# HOLDOVER

*Revised*

## **DAWES LAKE TRACE SUBDIVISION,** **FIRST ADDITION**

# DETAIL SITE PLAN

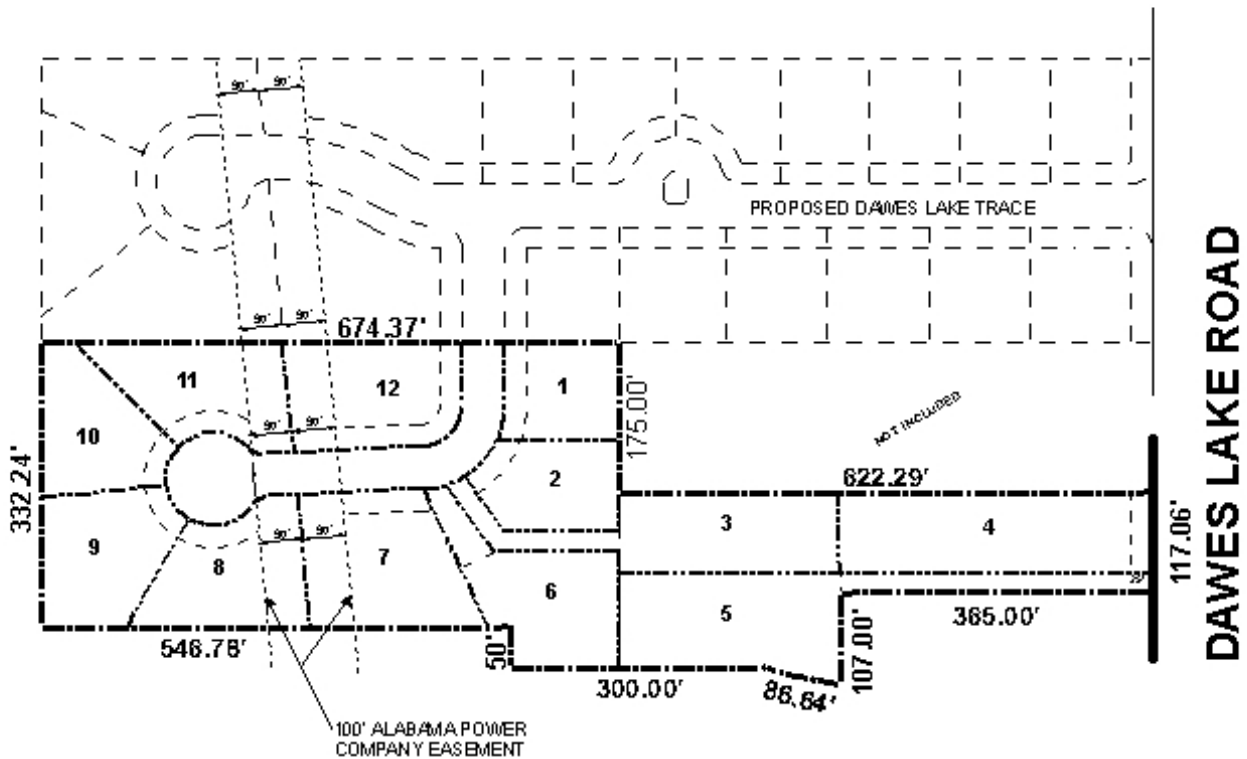
Detention is not shown on the plat; any detention areas should be marked as such, and a note should be placed on the final plat stating that maintenance of detention areas will be the responsibility of the property owners.

Proposed Lots 3, 5, and 6 are flag-shaped lots; these are uncharacteristic of other properties in the area and thus are not in conformance with Section V.D.1. of the Subdivision Regulations, which reads: "*The size, width, depth, shape, and orientation of lots and the minimum building setbacks lines shall be appropriate to the location of the subdivision and the type of development and use contemplated.*" Approval of this subdivision request could result in future requests for subdivisions with flag-shaped lots.

Based on the preceding, this application is recommended for Holdover, to allow the applicant to submit a revised plat that does not contain flag-shaped lots.

*This application was held over from the August 4<sup>th</sup> meeting to allow the applicant to submit a revised plat that did not contain flag-shaped lots. As no revisions have been submitted, and based on the preceding, this application is recommended for denial.*
